CABINET MEMBER FOR ENVIRONMENT– 24 NOVEMBER (13 OCTOBER) 2016

PROPOSED PUFFIN CROSSING – CUMNOR HILL, CUMNOR

Report by Deputy Director for Environment & Economy (Commercial)

Drawing title
**PUFFIN CROSSING
 PROPOSED LOCATION
 ANNEX 2**

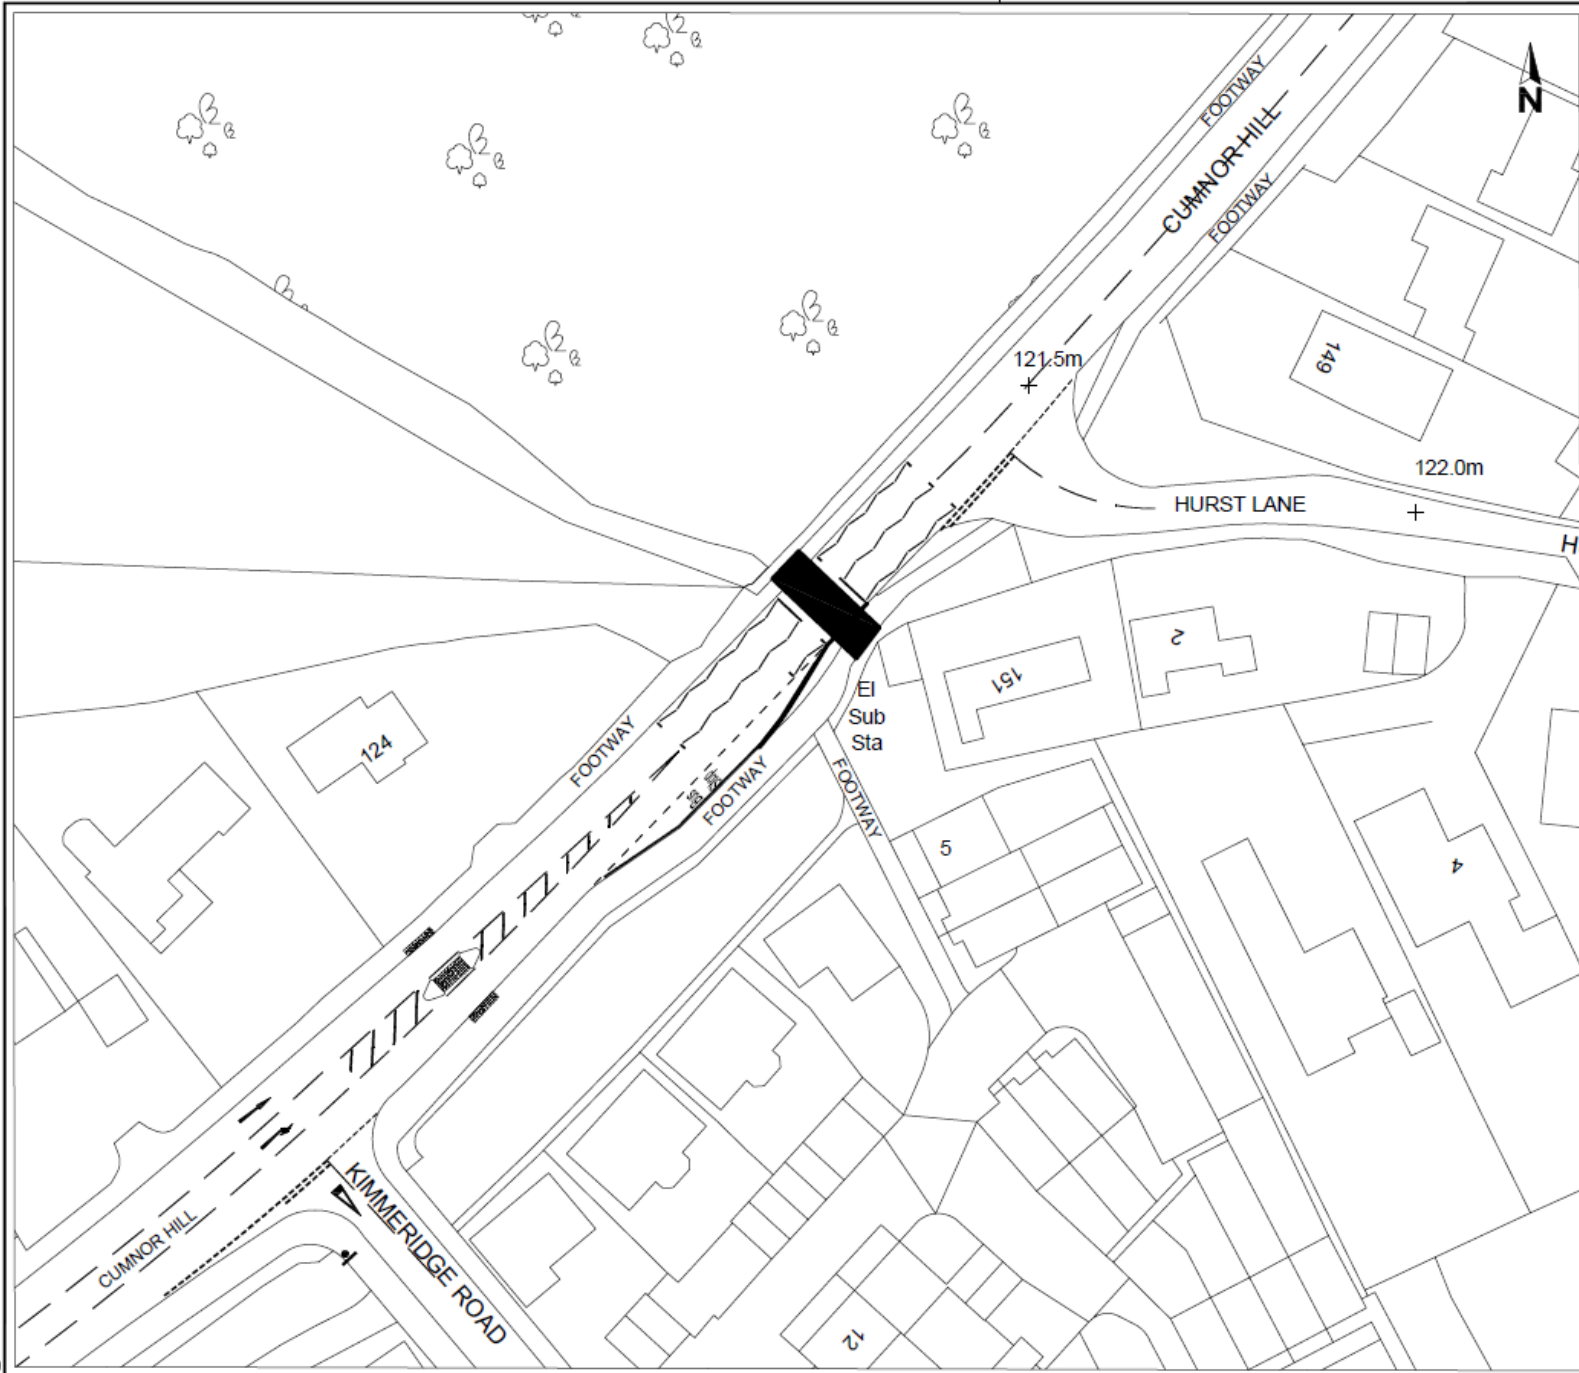
6. The main issue raised by those objecting to the proposed crossing concerned its location, with most feeling that it should be further west of the proposed site. In response, it is accepted that at present there are a variety of places where pedestrians cross Cumnor Hill but the conclusion drawn from the survey undertaken by the Parish Council recommended the

8. The owner of the land to the north of the proposed crossing objects as it is immediately adjacent to an existing vehicular entrance into the field behind. The landowner believes the presence of the crossing would cause obstruction to large agricultural vehicles entering or leaving and a danger to pedestrians using the crossing. In response, officers met the objector on site to discuss his concerns. Computer modelling has been undertaken of the movement of all likely vehicles to use this access and the results (which show the crossing would have no adverse effect on the access) have been passed to the landowner.

9. Other concerns raised relate to the closeness of the proposed crossing to Hurst Lane and the existing bus stop, and the noise arising from the audible beepers. These are matters of detail which can be addressed following safety audits of the final design.

10. Finally, some respondents sought the removal of the existing pedestrian refuge located west of the site of the proposed puffin crossing. Whilst its removal might encourage more use of the new crossing, its retention would continue to have a calming effect on traffic (by narrowing the road) and also protect vehicles waiting to turn right into Kimmeridge Road. It is therefore proposed to retain the refuge at least initially and to keep its presence under review.

7. Another main concern raised was the narrowness of the northern footway near the proposed crossing location. It is acknowledged that this is currently heavily overgrown and the verge has encroached onto the footway; both these issues will be addressed during construction of the crossing which will then mean a footway of adequate width is provided.

Drawing title
 PUFFIN CROSSING
 PROPOSED LOCATION
ANNEX 3

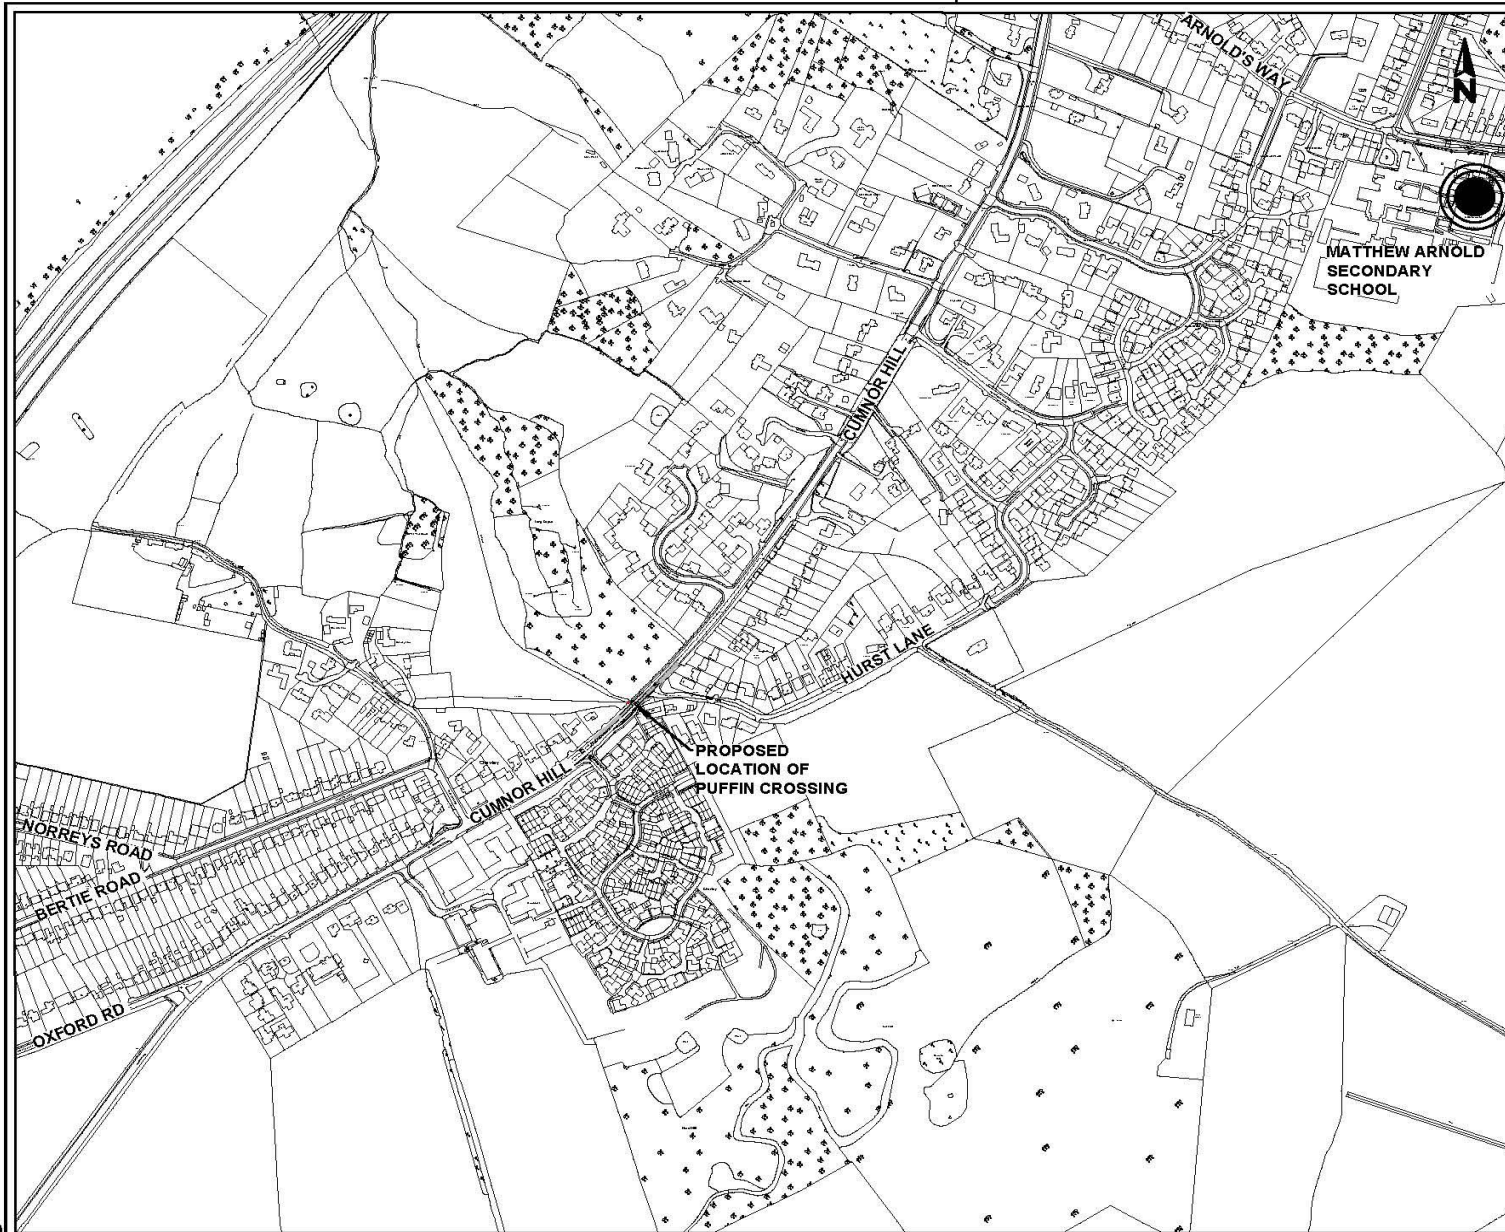
RESPONDENT	SUMMARISED COMMENTS
Thames Valley Police	<p>No objection providing this layout meets the approved standards</p> <p>The following issues have been raised:</p> <ul style="list-style-type: none"> • The footway on the north side is extremely overgrown and reduced in width by overhanging foliage. This foliage also seriously restricts visibility of traffic from the westbound direction and considerable cut back is essential. • Whilst on site, saw no desire to cross at this point (there is an existing crossing point further west towards Kimmeridge Road) and enquires whether as part of the proposal that crossing point will remain or be removed. Leaving it in situ may discourage use of the new formal crossing point.
Cumnor Parish Council	Ask that the existing central reservation be removed prior to the puffin crossing being installed.
Resident on the Cumnor Development	Respondent suggests that the crossing could be better placed, i.e. nearer to the car garages i.e. past the development if coming up from Botley.

No address given	<p>Respondent objected for the following issues:</p> <ul style="list-style-type: none"> • Crossing will only be used at peak times, if at all. • In completely wrong position for large housing development • Noise pollution from beeping crossing and vehicles accelerating/deceleration

<ul style="list-style-type: none"> • Too close to junction of Hurst Lane, creates bind spot • Right next to a grade 2-listed cottage C16, will adversely affect value and heritage (English Heritage have been consulted) • Right next to electricity sub-station, not a great idea as it will mean gatherings of youths presenting obvious danger to life • Crossing better placed further west
No address given	The point at which the crossing is proposed is a very narrow point and the footway on the opposite side to Hurst Lane is particularly narrow, making it a less suitable crossing point than the islands further up the Hill nearer to Kimmeridge Rd after the bus stop. More pedestrians are likely to use the point here.
No address given	Respondent believes the crossing is in the wrong place and will not pick up children at it's proposed location.
Resident on Cumnor Hill	<p>The owner of the land to the north of the above proposal strongly objects to the location of the Puffin Crossing as this is immediately adjacent to an existing vehicular entrance into the field behind. It would cause obstruction to large agricultural vehicles entering or leaving and a danger to pedestrians using the crossing.</p> <p>Respondent suggests that more suitable location of the crossing for those aiming for the village and the school be Kimmeridge Road using the existing island crossing upgraded to a "Puffin", which has wider footpaths than the proposed one which are only one metre deep.</p>

No address given	<p>Respondent raises the following concerns after speaking to some residents who use the busses regularly:</p> <ul style="list-style-type: none"> • There is a pedestrian crossing on the proposed location, it would be more advantageous to put the puffin crossing on Chawley Lane opposite the Jaguar garage further up Cumnor hill where most school children and families get off to access the Cumnor Ridge estate. • As cars are coming off the carriageway they are coming down quite fast until they slow down much further down Cumnor hill road.

Resident on Cumnor Hill	Respondent raises the following issues: <ul style="list-style-type: none">• The current site lies too far down the Hill to be of use to most parents walking their children to school.• At its proposed site, the crossing would take people to an old, narrow pavement which in many places is overgrown and which often has cars parked half on the pavement outside the houses and also has a number of driveways to negotiate.• Proposed site is very close to the existing bus stop. Visibility around the crossing will necessary be reduced when there is a bus on the stand.
Resident on Cumnor Hill	Respondent raises the following concerns over its location. <ul style="list-style-type: none">• Crossing sited in the wrong location• Proposed crossing location is too close to Hurst Lane and the bus stop
Resident from Kimmeridge Road	In full support of the planned puffin crossing.
